STATE BUILDING CODE TECHNICAL REVIEW BOARD

Friday, May 21, 2021 - 10:00am (Virtual Meeting)

49
50 Appeal of Monica and Michael Davis; Appeal No. 20-03:
51
52 After review and consideration of the final order presented in the
53 Review Board members' agenda package, Mr. Payne moved to approve
54 the final order with the suggested editorial change to delete "d" for the
55 word "required", creating the word "require", in line 100 on page 37
56 and remove the word "do" and replace it with the word "may" in line
57 157 of page 43 of the agenda package. The motion was seconded by
58 Ms. Jackson and passed with Messrs. Pharr, Givens, Hutchins, and
59 Mays abstaining.

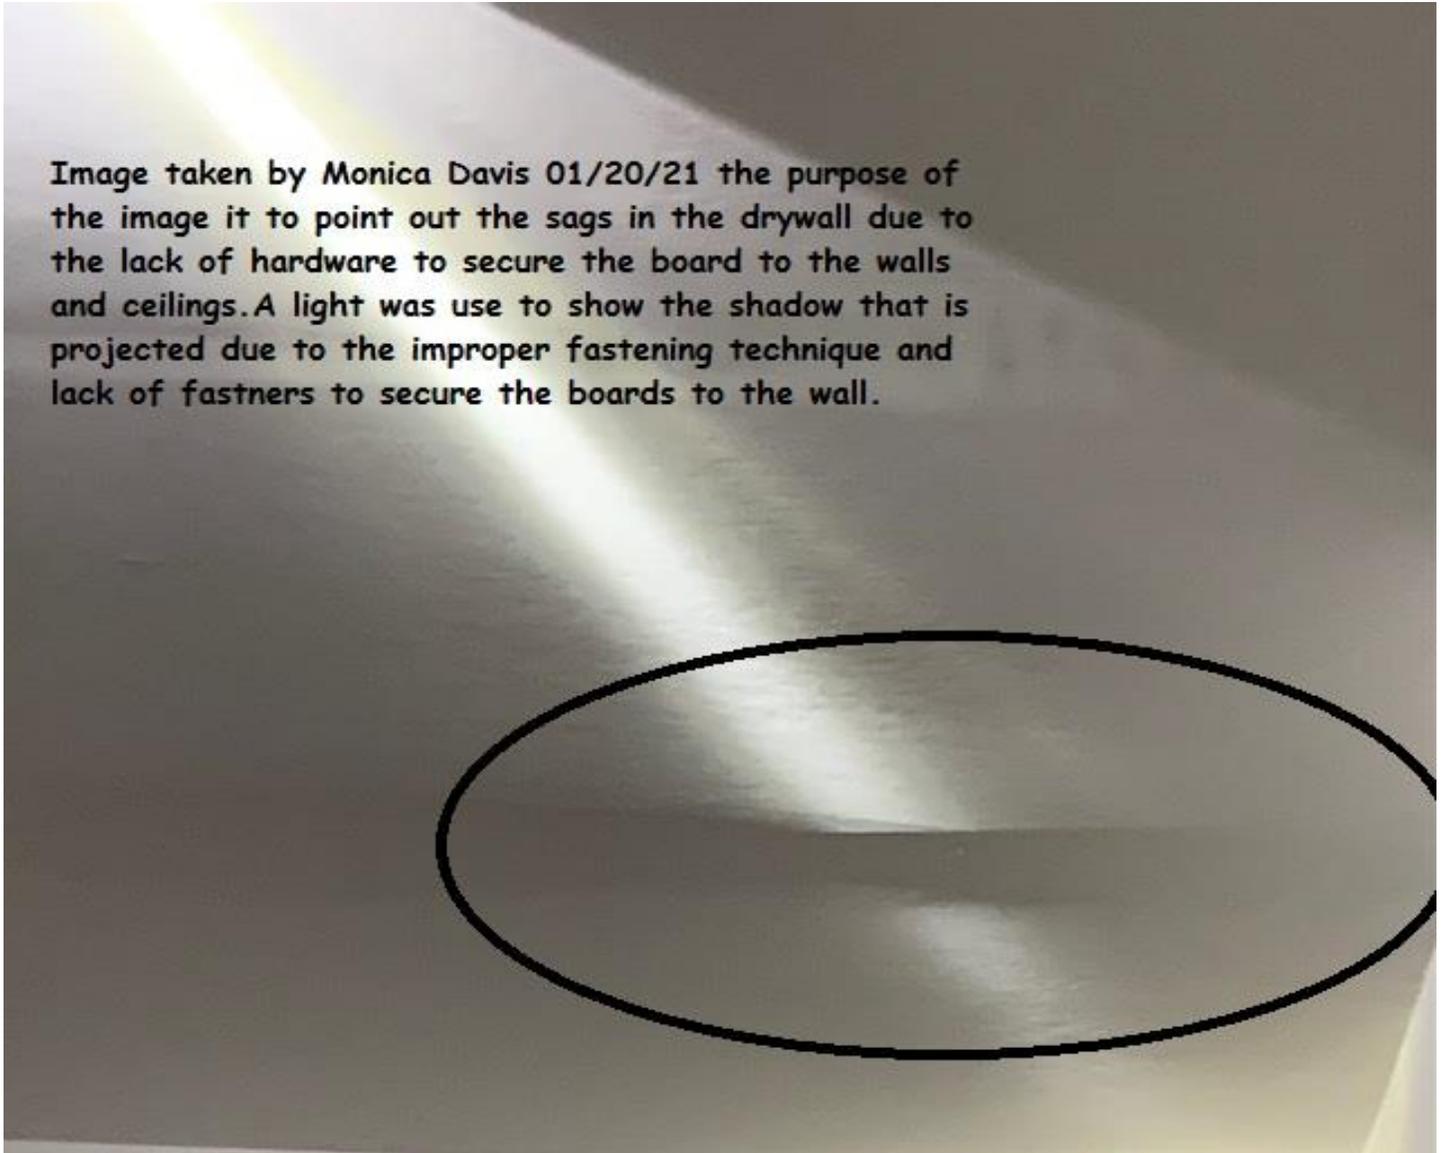
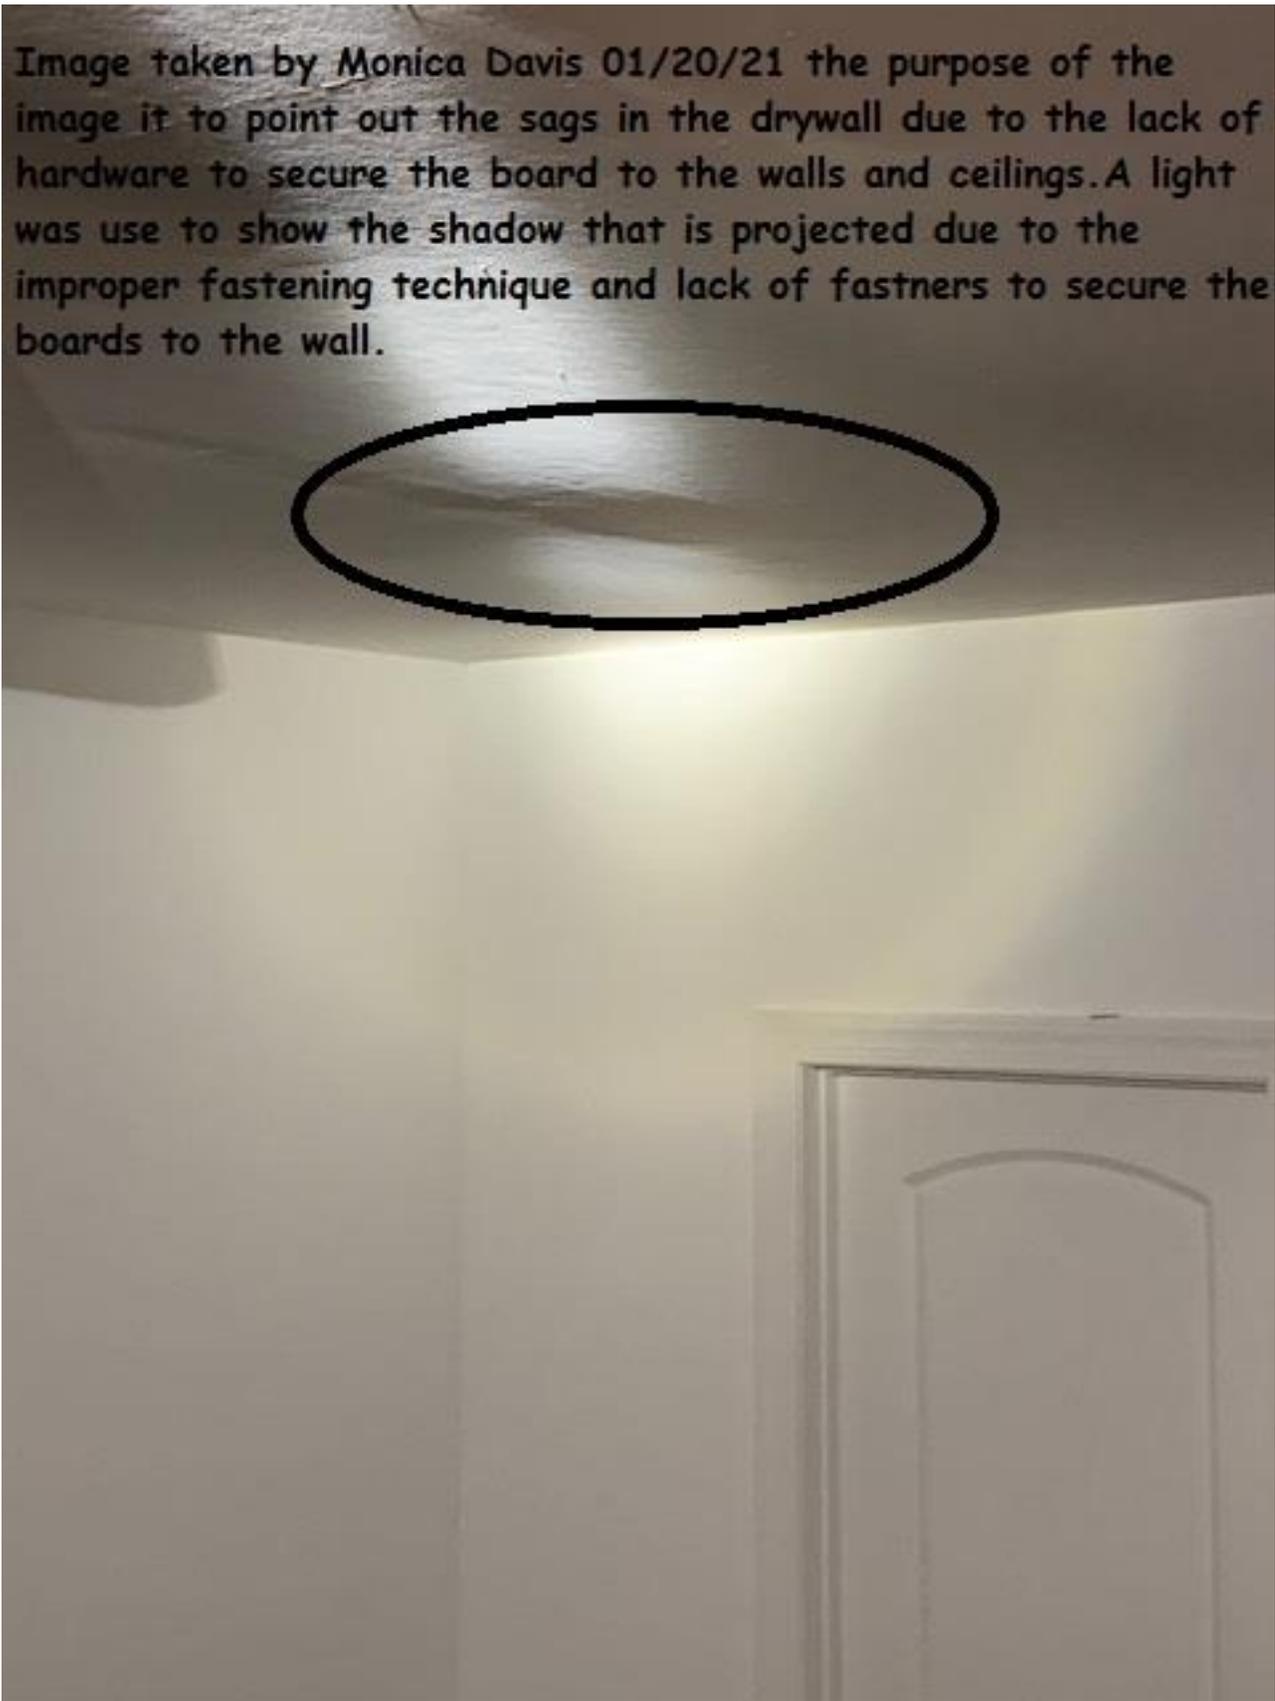
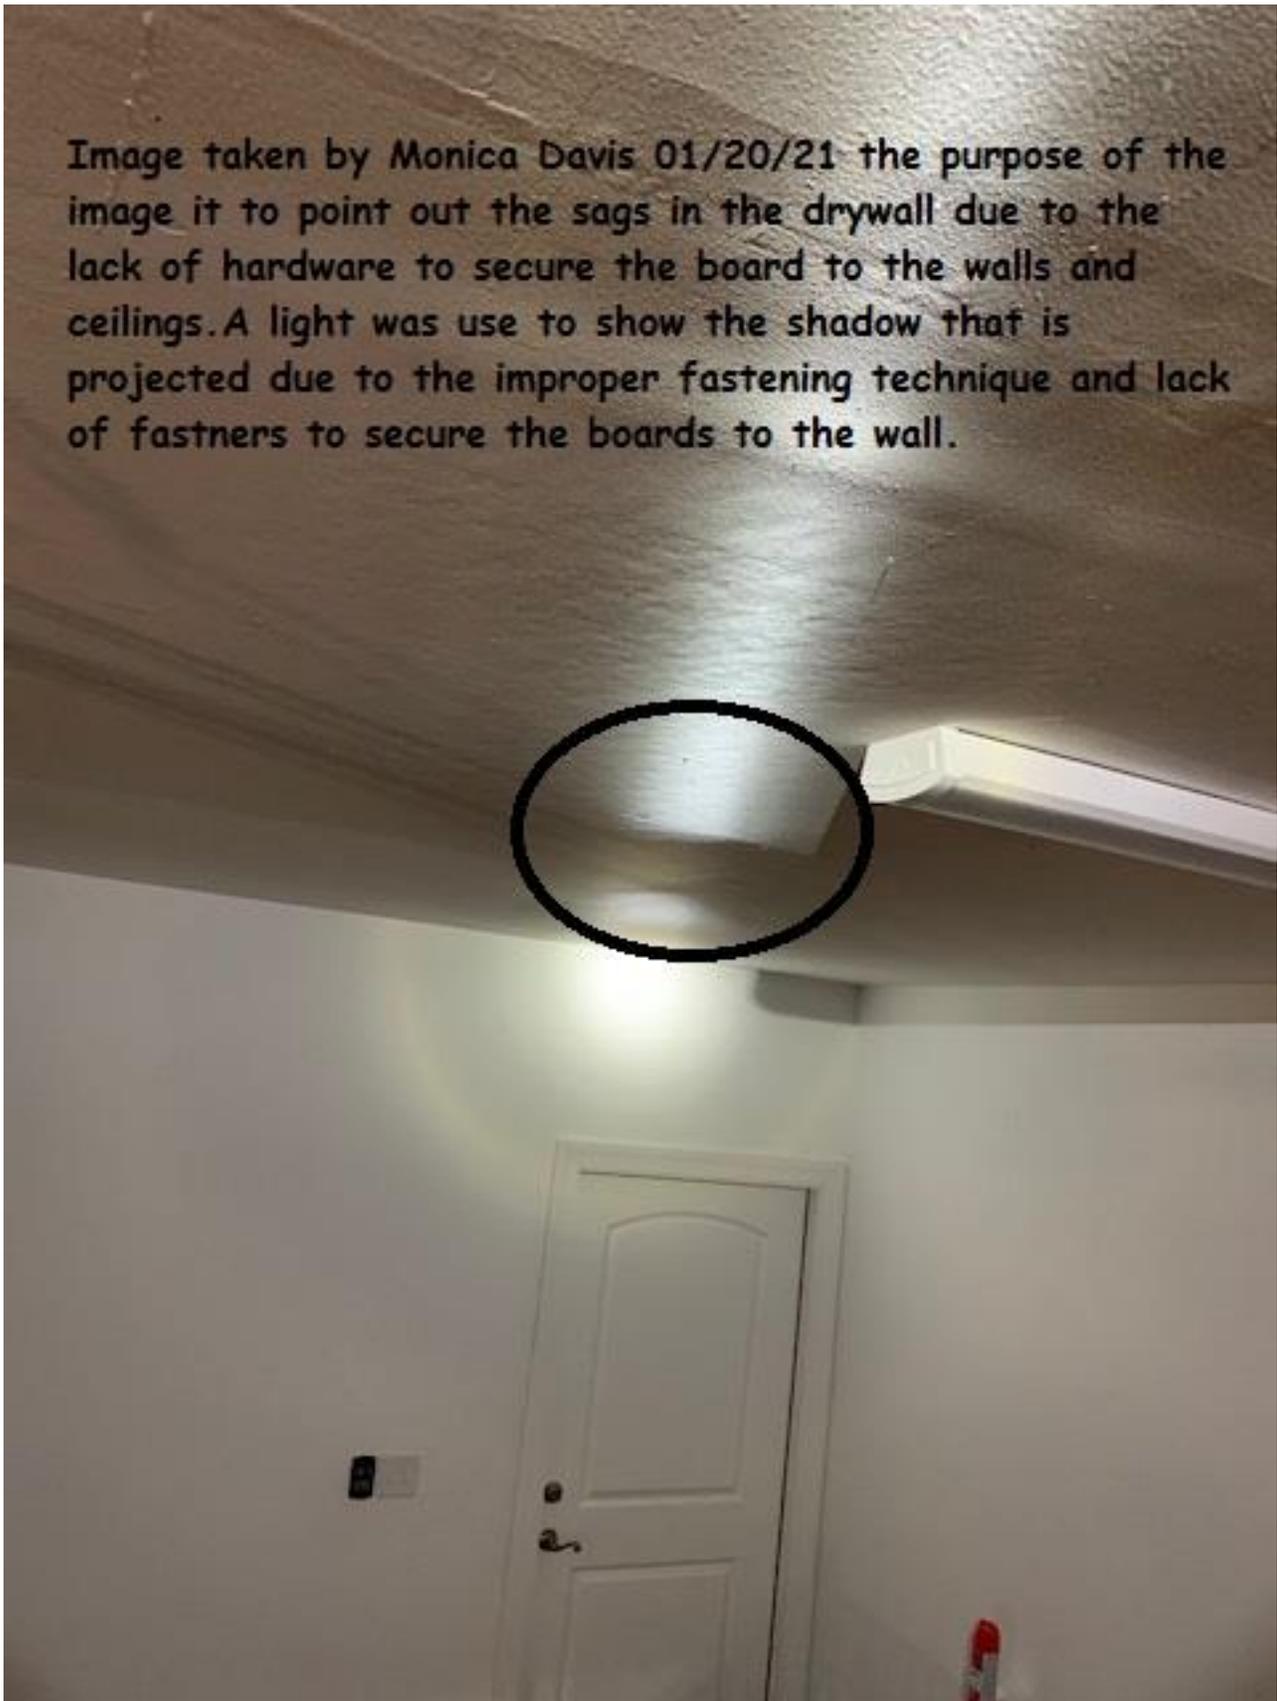
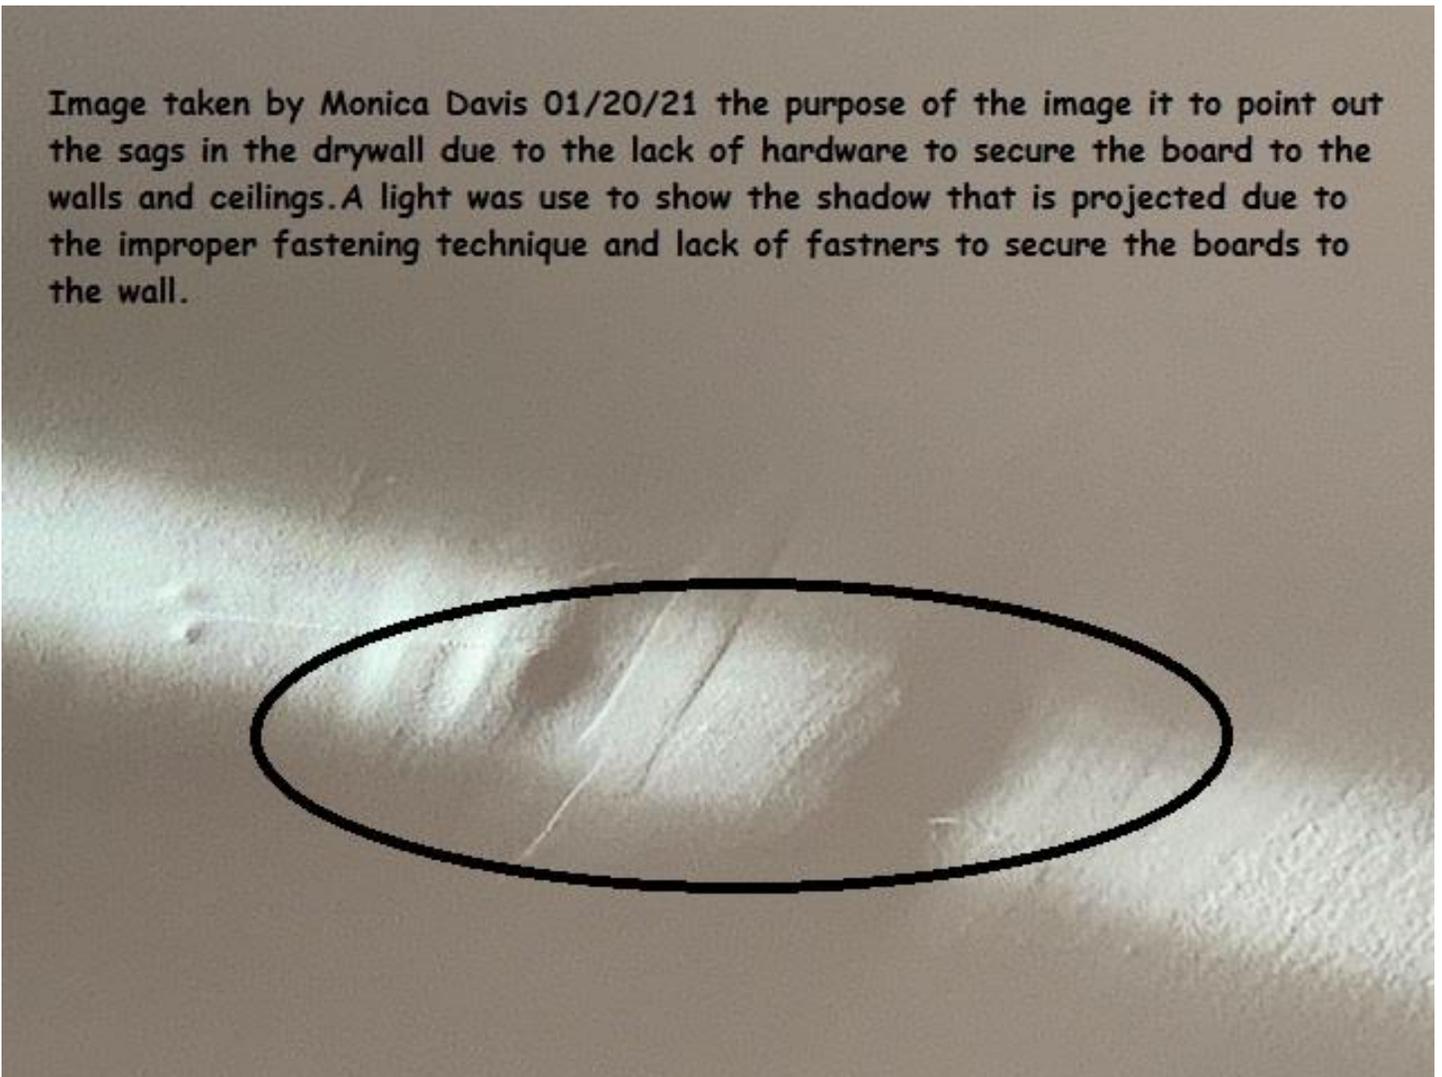
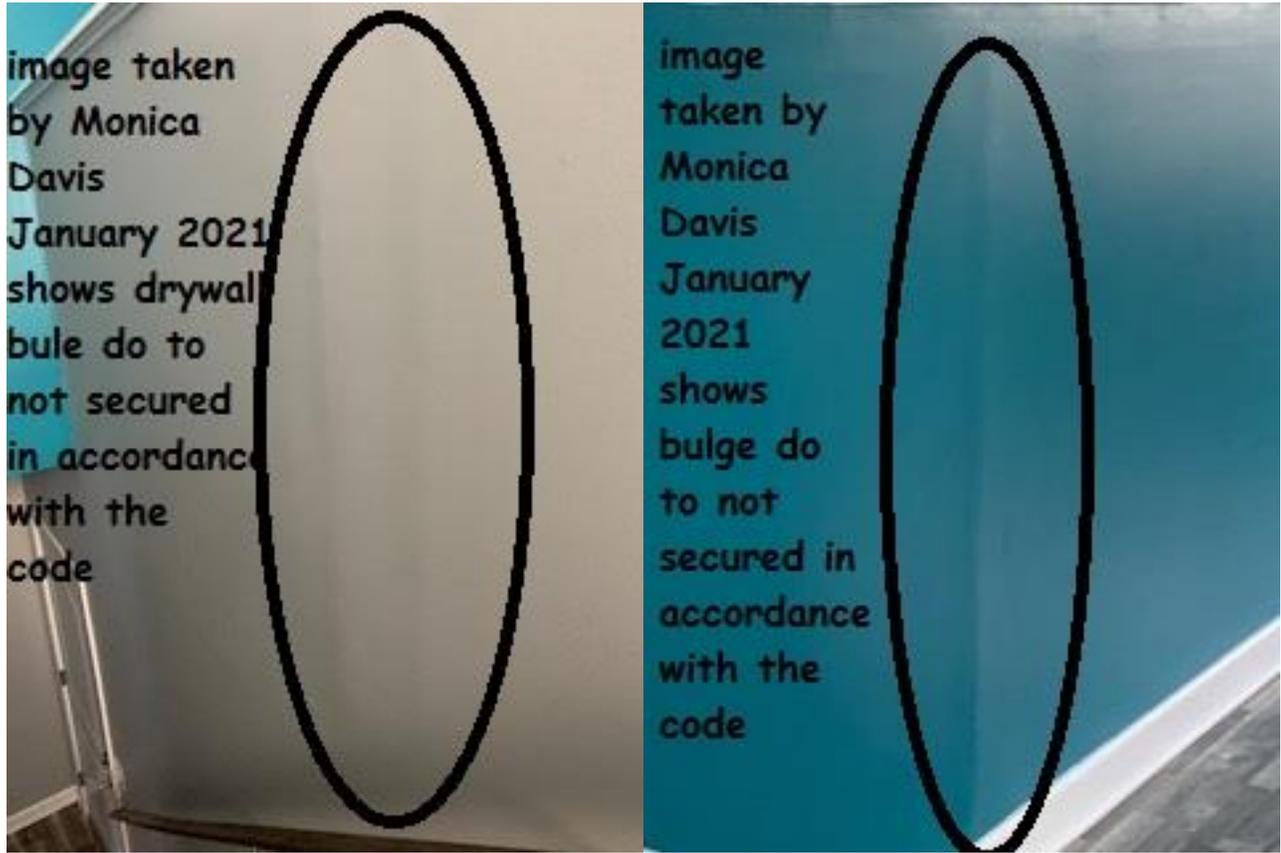
Image taken by Monica Davis 01/20/21 the purpose of the image is to point out the sags in the drywall due to the lack of hardware to secure the board to the walls and ceilings. A light was used to show the shadow that is projected due to the improper fastening technique and lack of fasteners to secure the boards to the wall.

Image taken by Monica Davis 01/20/21 the purpose of the image is to point out the sags in the drywall due to the lack of hardware to secure the board to the walls and ceilings. A light was used to show the shadow that is projected due to the improper fastening technique and lack of fasteners to secure the boards to the wall.

Image taken by Monica Davis 01/20/21 the purpose of the image is to point out the sags in the drywall due to the lack of hardware to secure the board to the walls and ceilings. A light was used to show the shadow that is projected due to the improper fastening technique and lack of fasteners to secure the boards to the wall.

Image taken by Monica Davis 01/20/21 the purpose of the image is to point out the sags in the drywall due to the lack of hardware to secure the board to the walls and ceilings. A light was used to show the shadow that is projected due to the improper fastening technique and lack of fasteners to secure the boards to the wall.

image taken by Monica Davis January
2021 shows drywall cracked and
sagging do to not secured in
accordance with the code this

12. Per numerous photos of owner's taken after drywall finishing but before paint, the drywall was not secured in accordance with table R702.3.5. Need to correct to table R702.3.5 or provide an engineered design and approval in accordance with section R301.1.3.

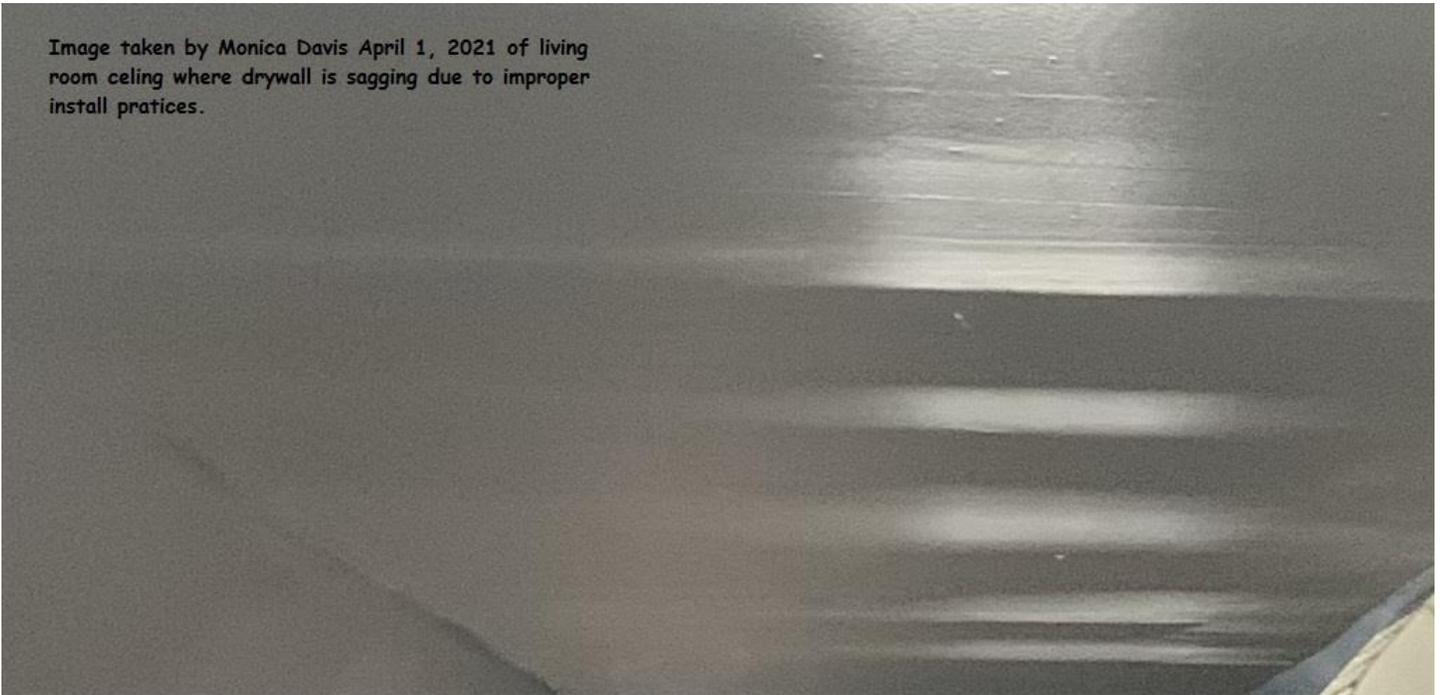
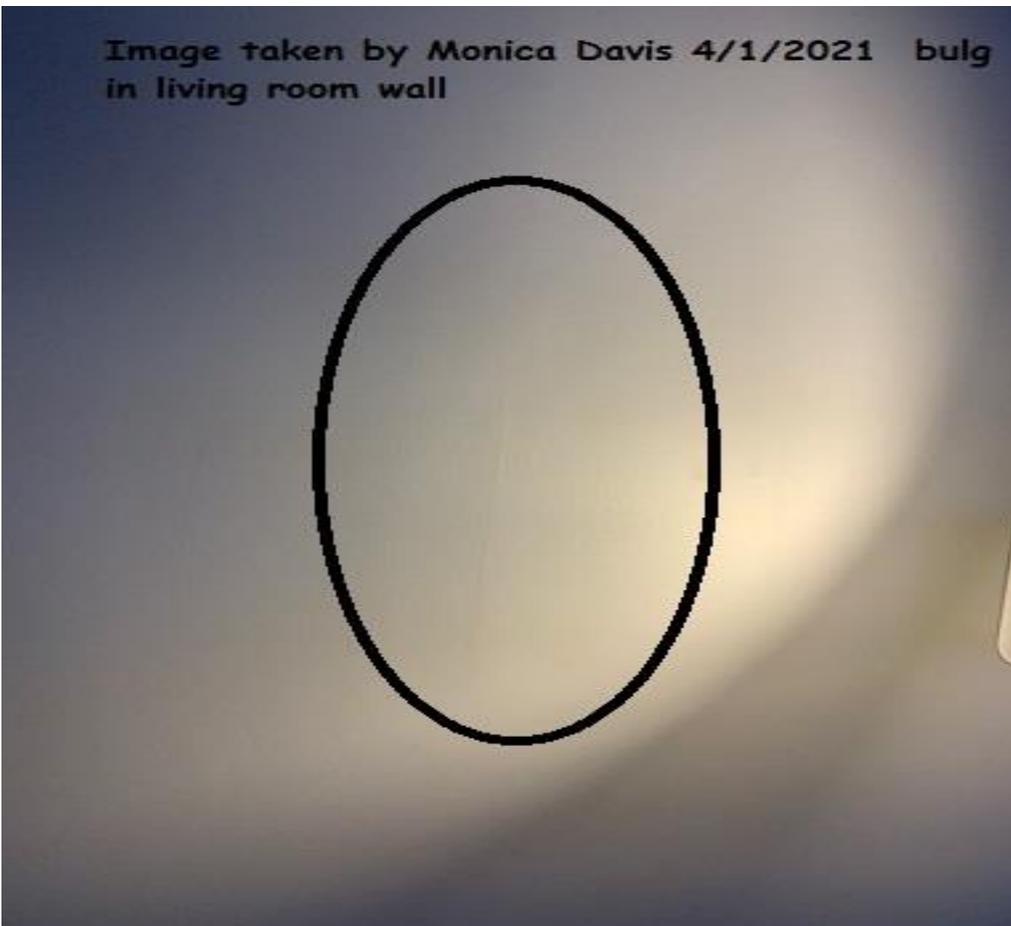
Image taken by Monica Davis April 1, 2021 of living room celing where drywall is sagging due to improper install practices.

Image taken by Monica Davis 4/1/2021 bulg in living room wall
